STATE OF MAINE
DEPARTMENT OF TRANSPORTATION
16 STATE HOUSE STATION
AUGUSTA, MAINE
04333-0016

December 28, 2006
Subject: **Topsham**
Pin No. 14062.11
Amendment No. 2

Work under this contract is generally described as the construction of the MaineDOT TOPSHAM HIGHWAY MAINTENANCE GARAGE

TITLE
2ND FLOOR MEZZANENE
FOUNDATION PLAN & SECTION

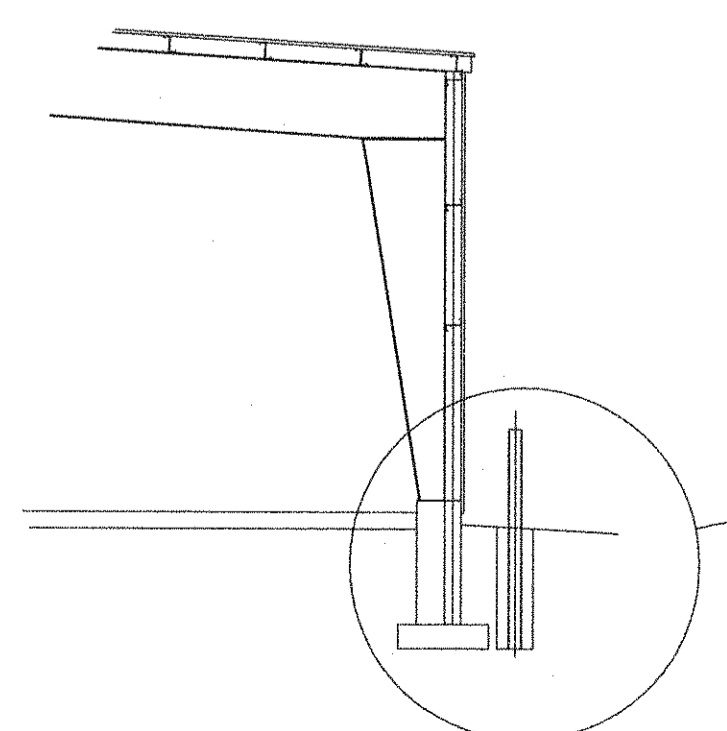
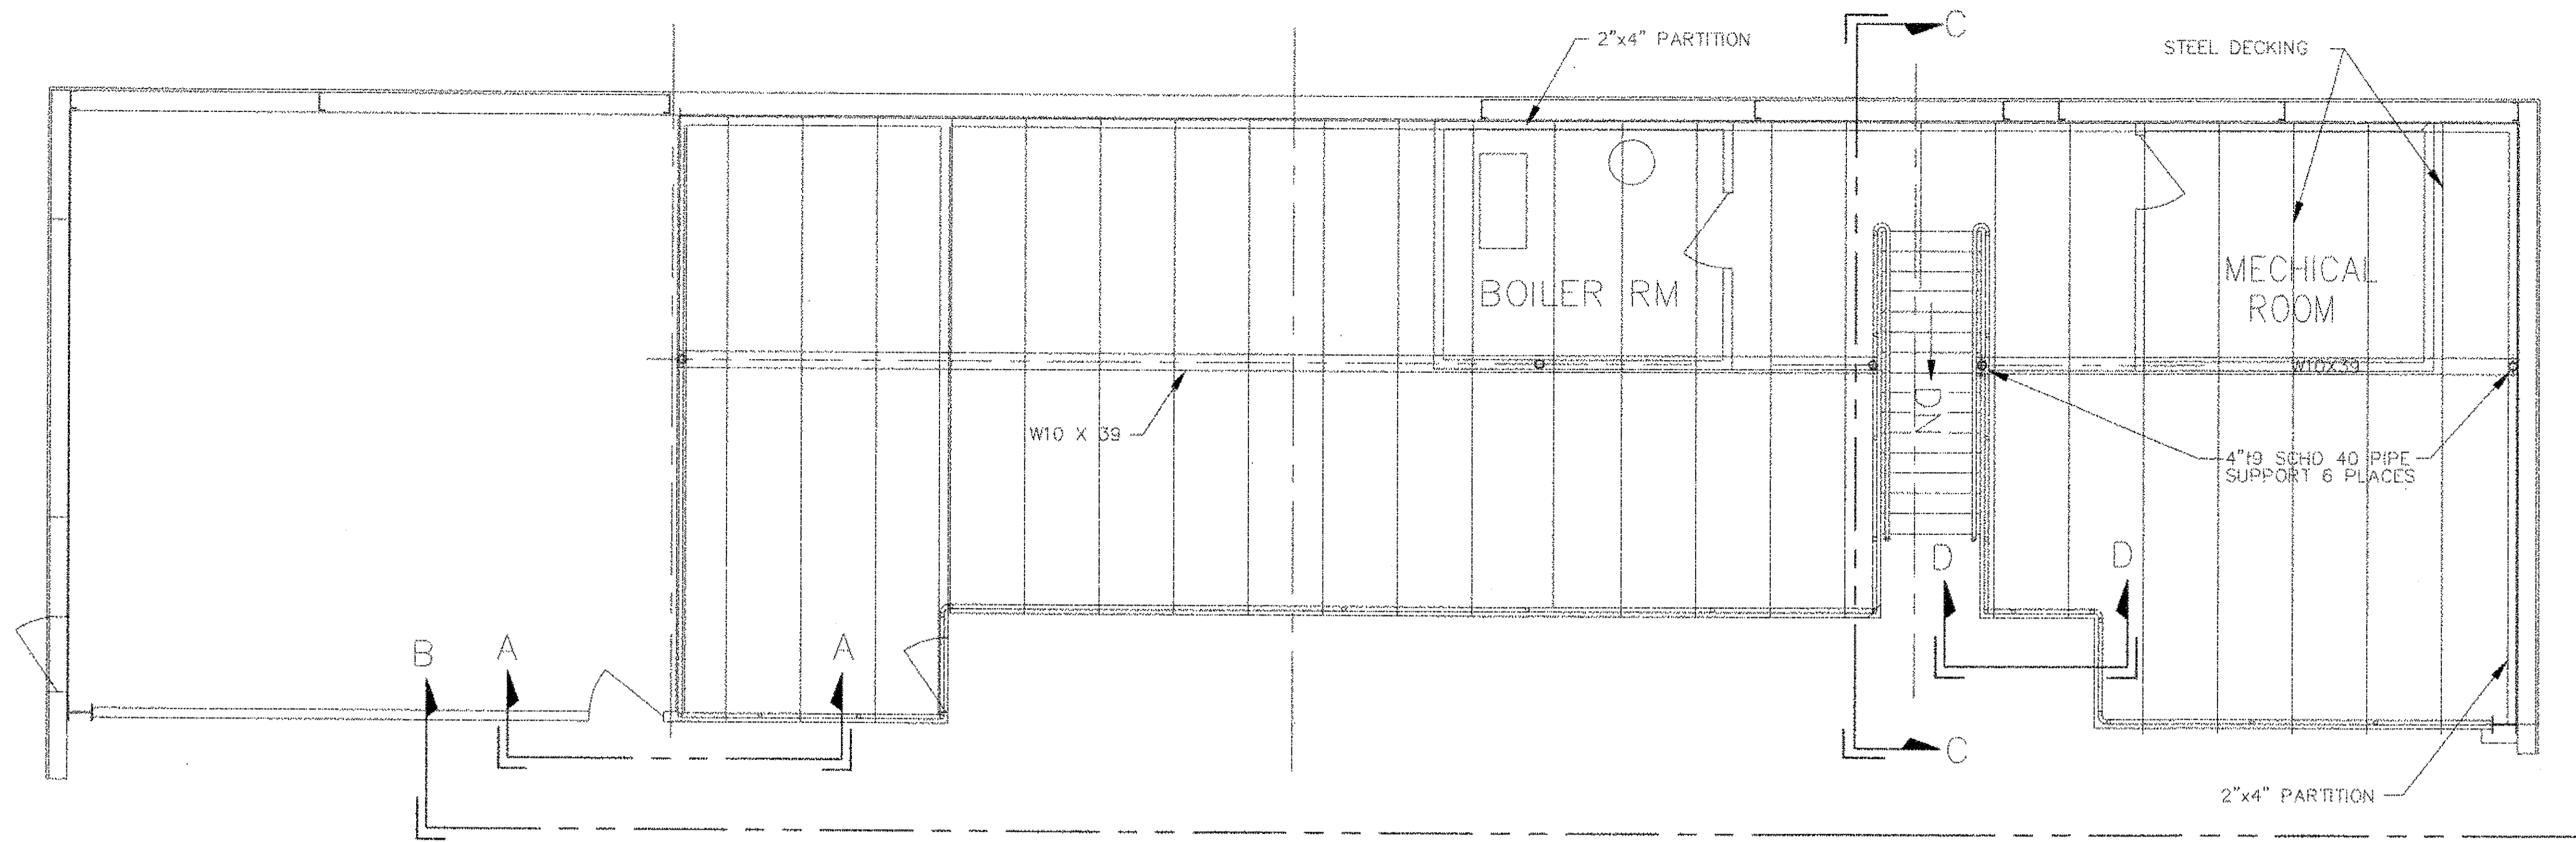
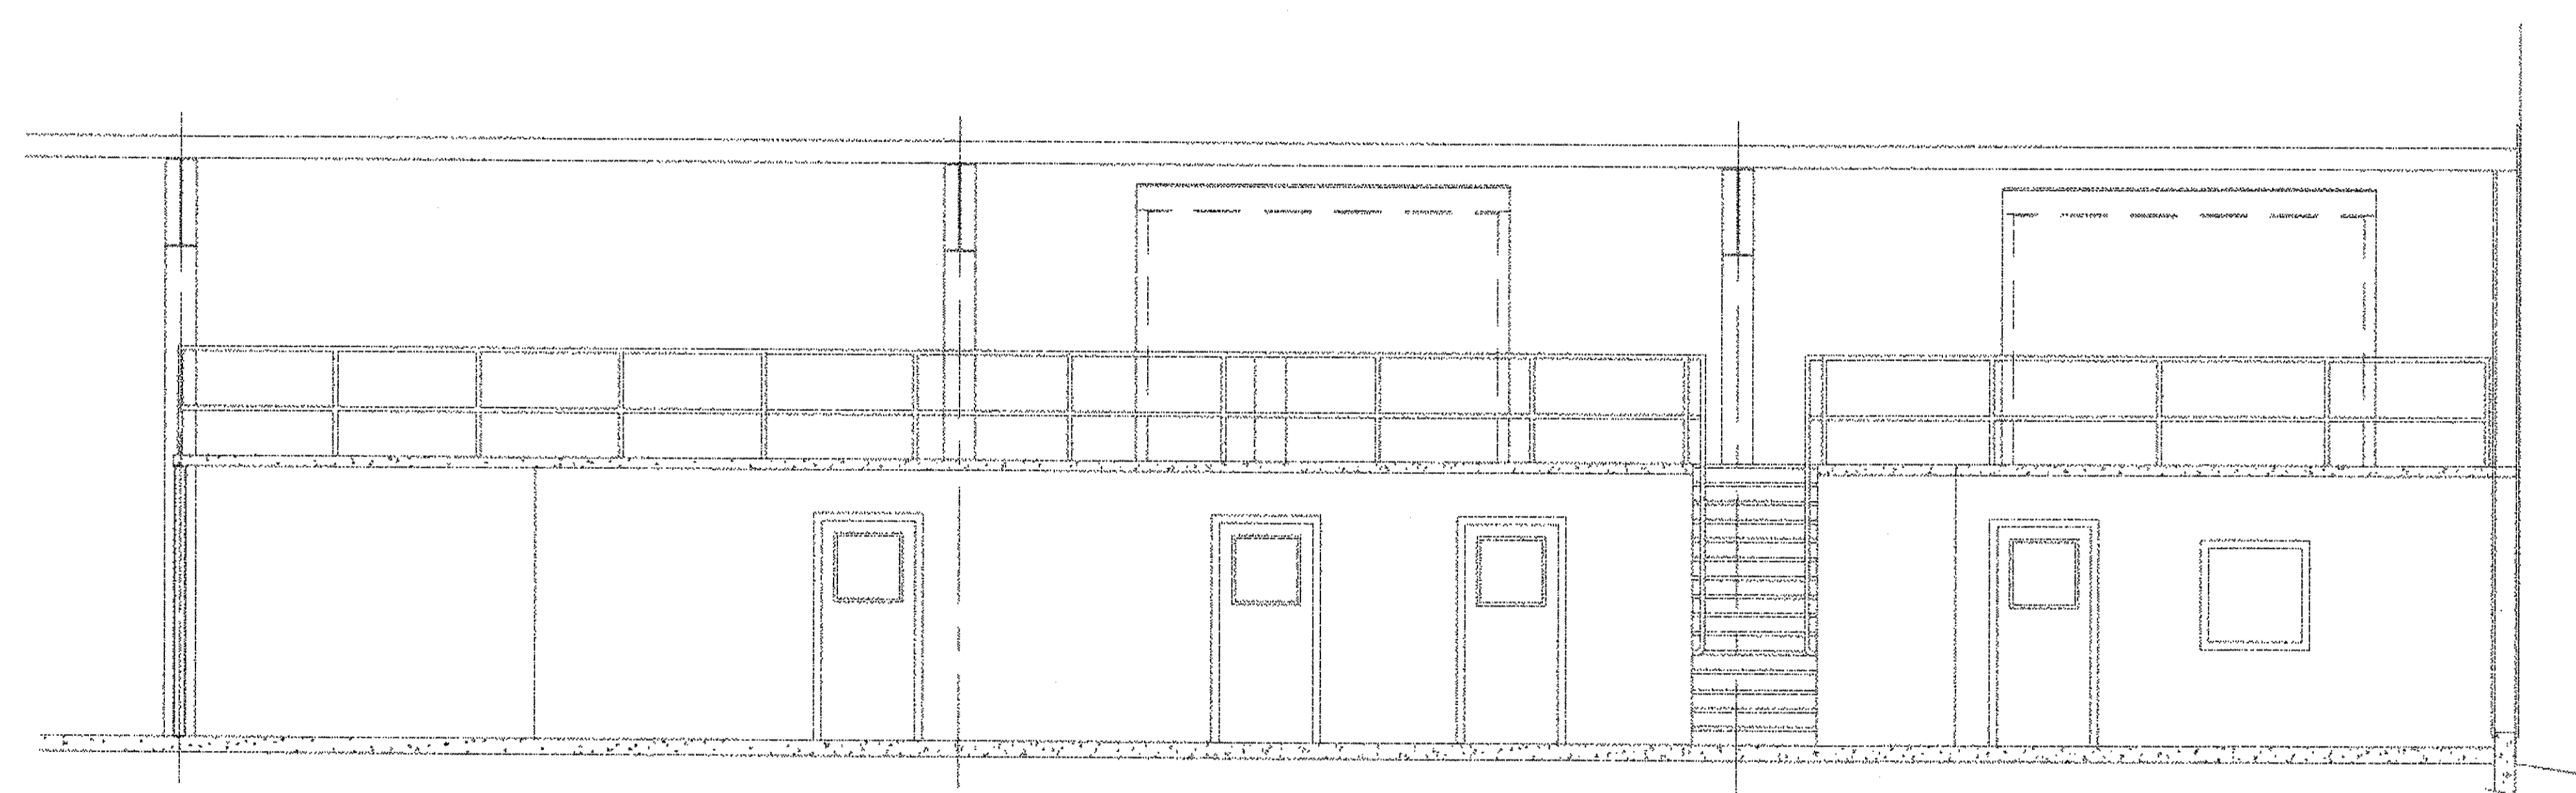
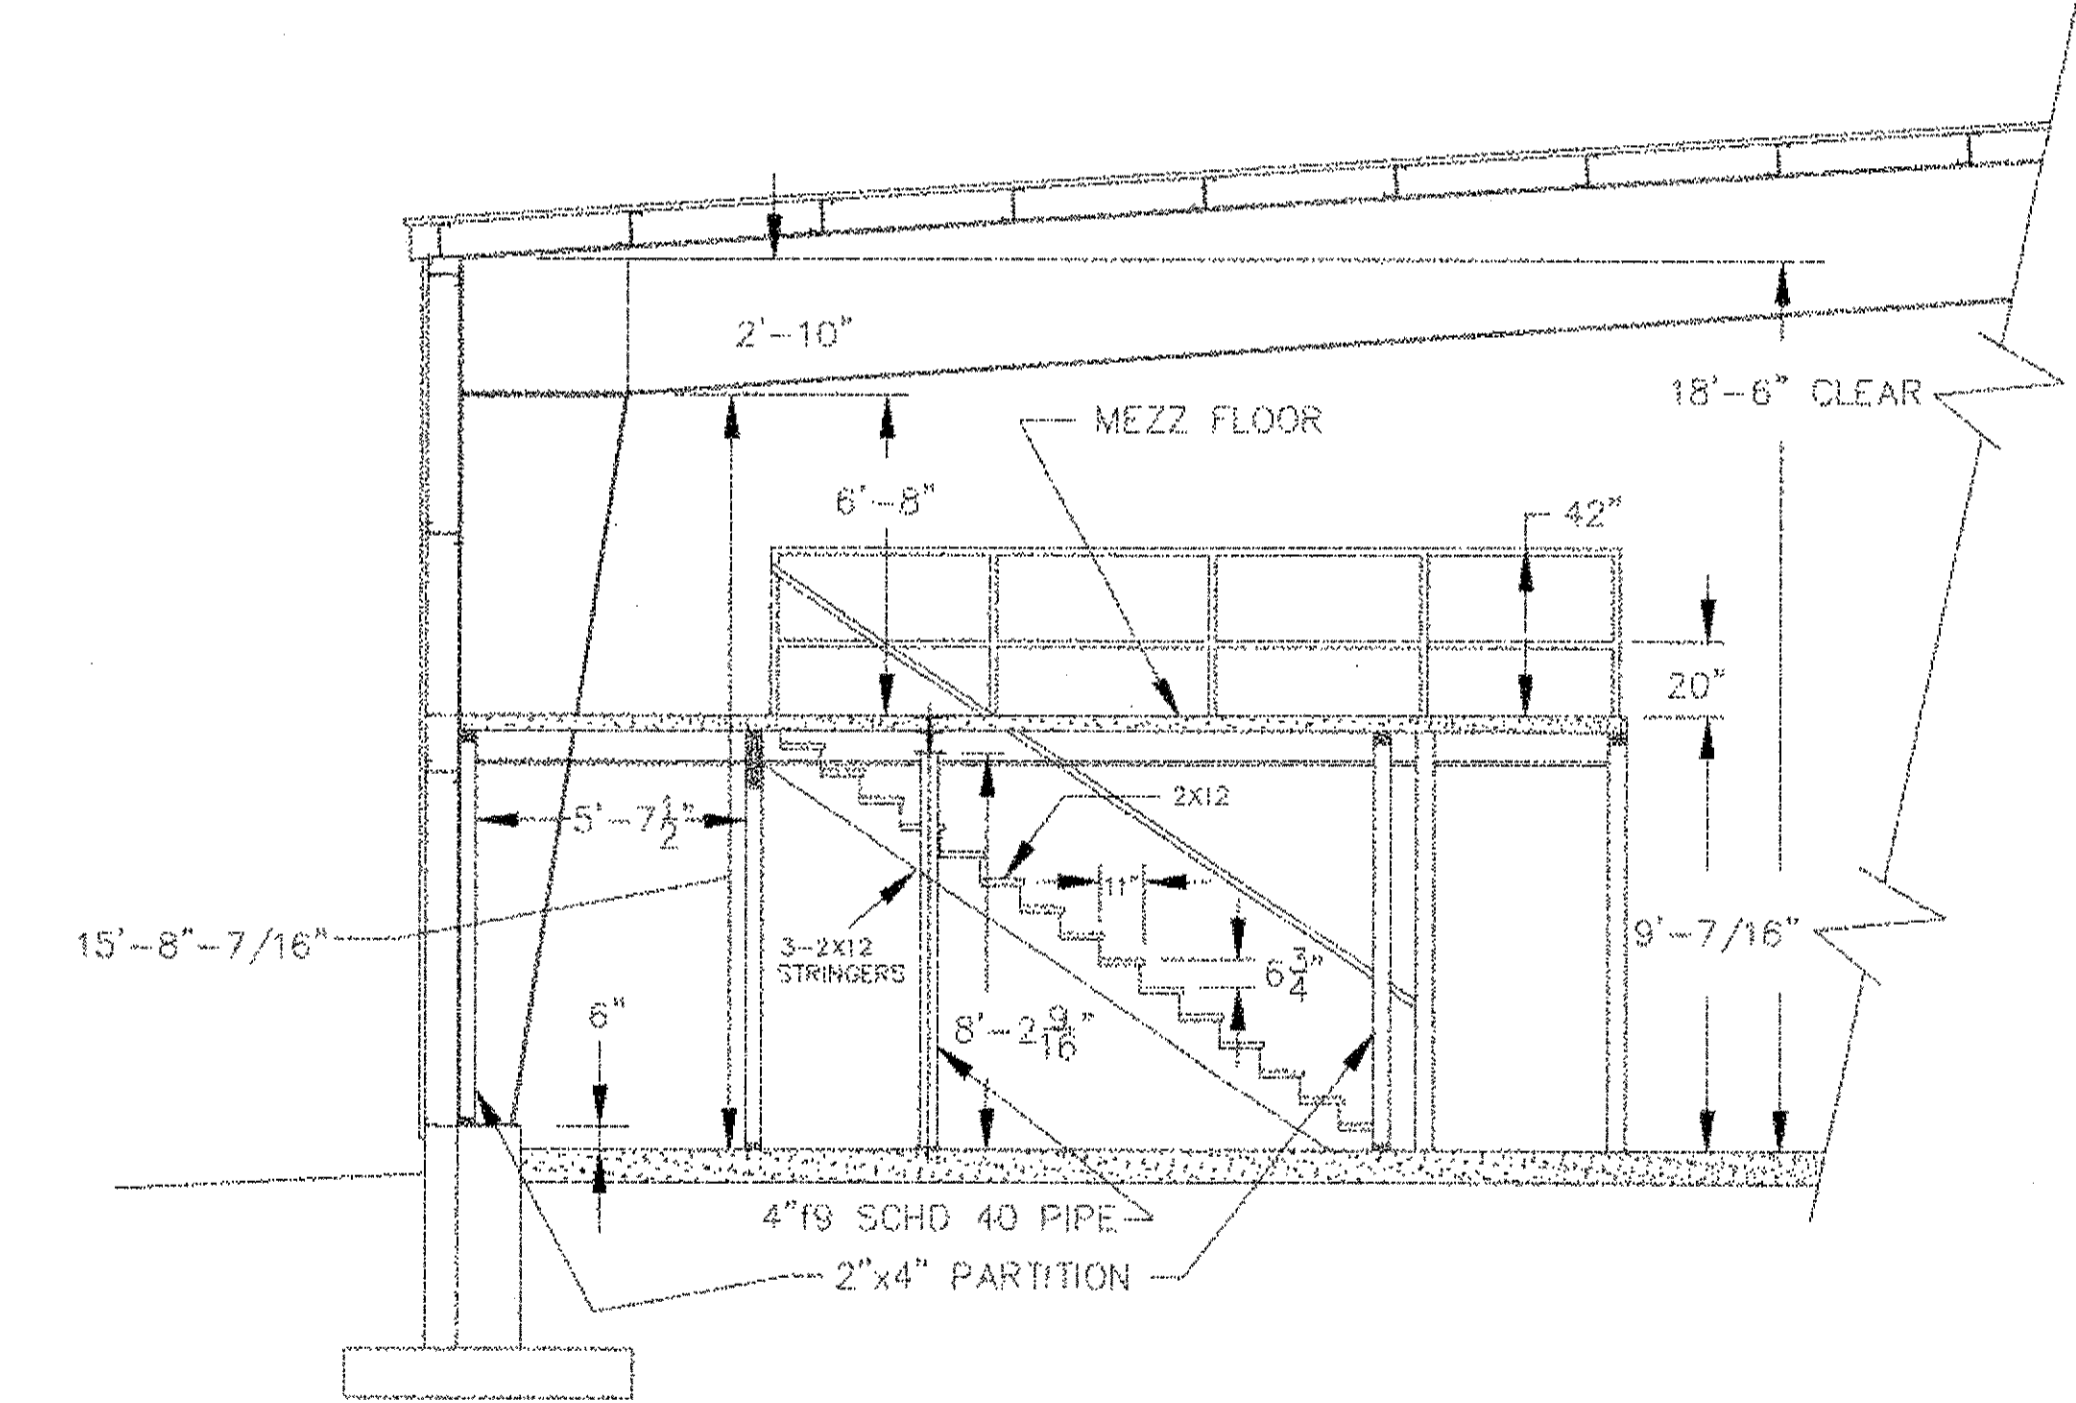
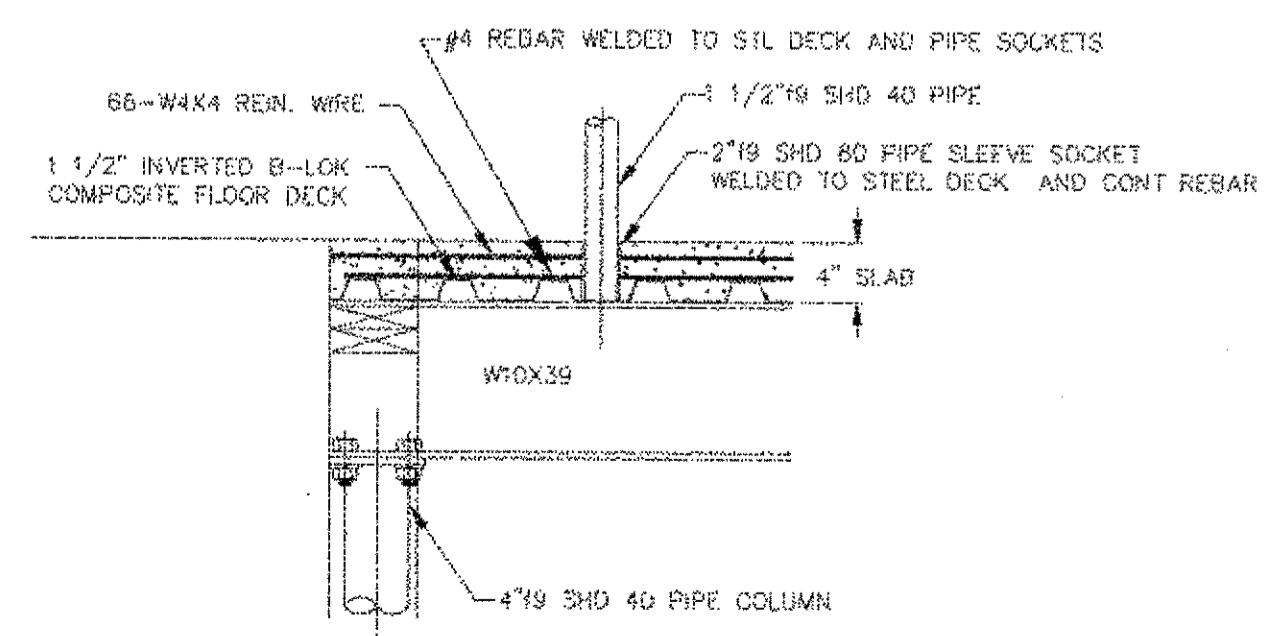
Question: On drawing MZ-2 Section A-A, is this footing detail only on line shown, or at all columns? It is not shown on Section C-C.

Question: On Drawing MZ-2, there are no dimensions, clear layout, or description of structural elements.

Question: Drawing MZ-2. What is construction of stairs?

Response: Drawing MZ-2 has been removed and replaced by the attached plansheet A-5A, and revisions have been made to Section A-A.

Response: The structural members have been identified on the attached A-5A plansheet.

Response: Stair details have been added on the attached A-5A plansheet.
